**KME Construction**  
12584 Hall Shop Road  
Fulton, MD 20759

Property address:  
15870 Union Chapel Rd  
Woodbine, MD 21797

I am requesting a waiver to the Percolation Certification Plan requirement for the following reasons:

SITE INSPECTION SHEET

LOCATION DIAGRAM

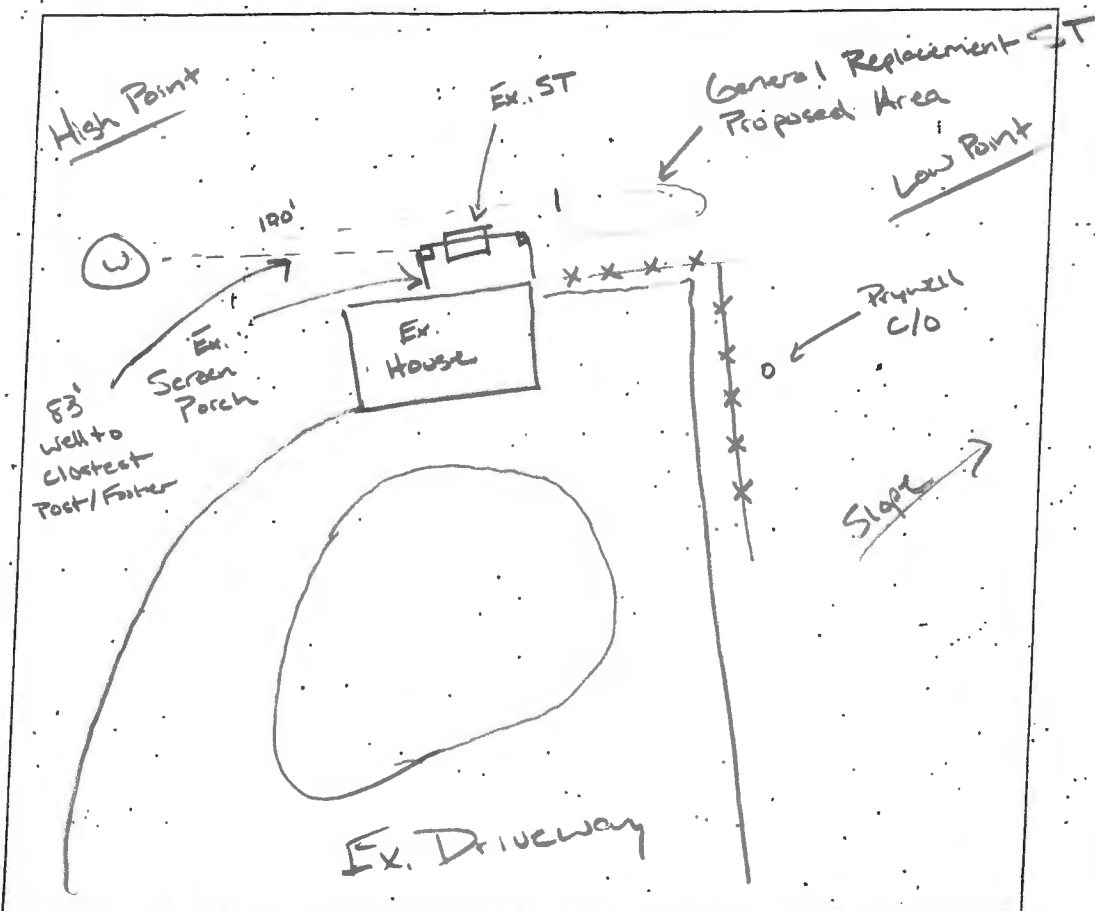
COMMENTS: Ex Septic Tank under fasteners of screen porch. Contractor for sunroom is proposing to replace/relocate tank. Existing OSDS does not appear to be failing. C/O on dry well needs to be replaced. Dry well does still have life left in it. Well appears in good condition. Sunroom will be within 100' of well.

# Floor Plan

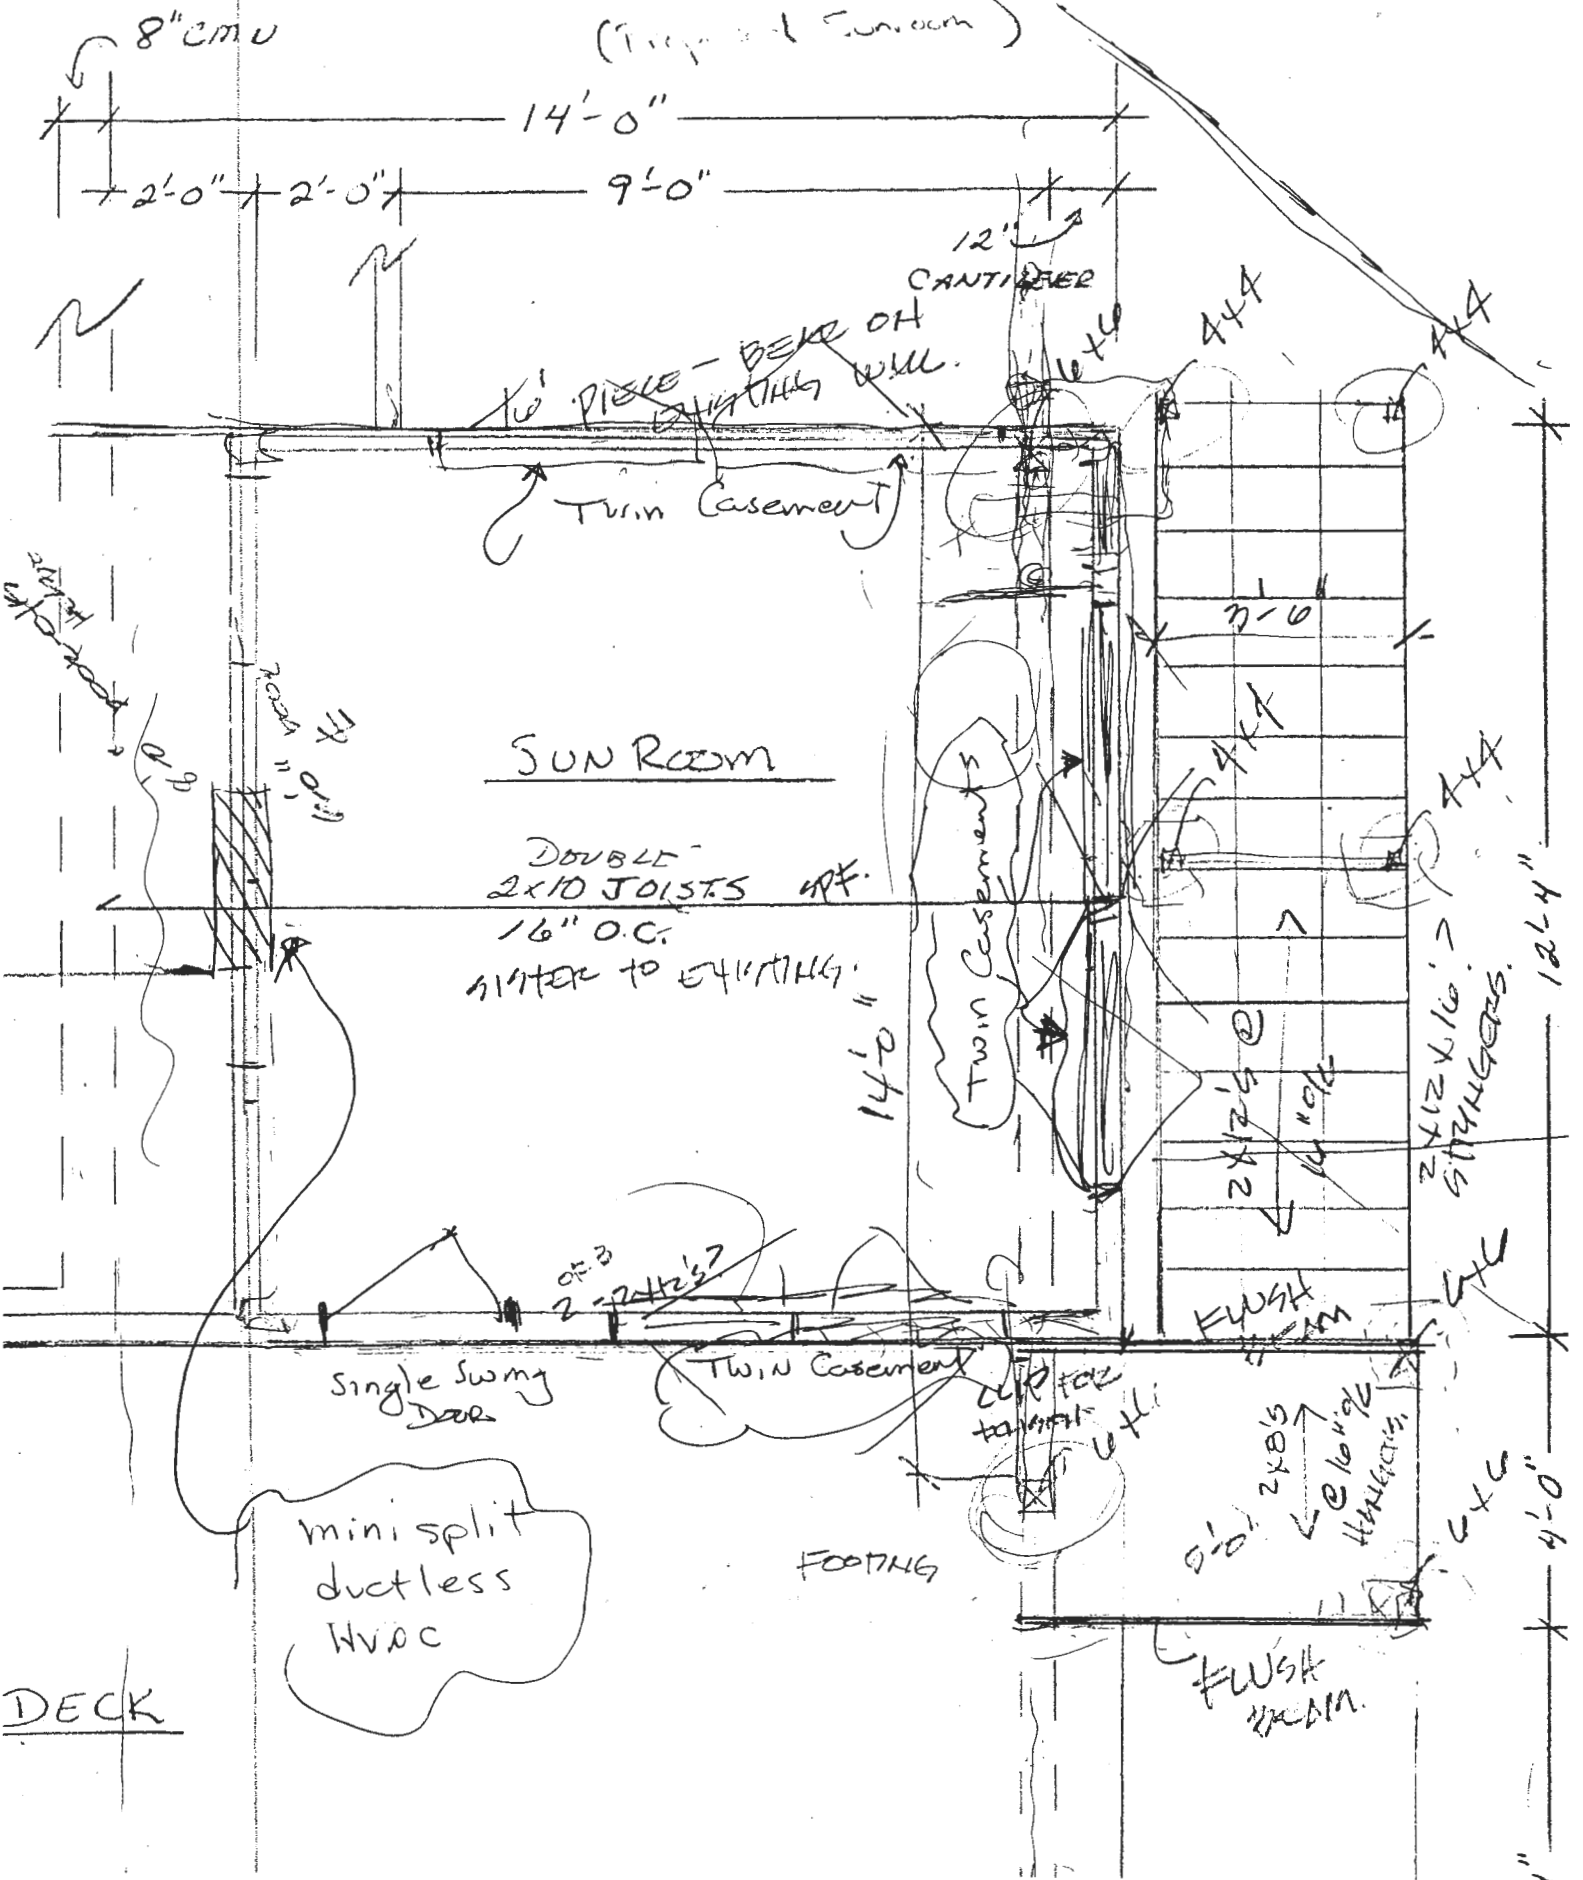
Owner is proposing sunroom  
in place of existing screen porch.  
No footprint increase is  
under 250sqft. Need to  
relocate tank. Sunroom  
contractor Ken Erskine  
asking for...

- Tank Replacement Permit
- Waiver to PC requirement  
(Both Dropped off 7/25)
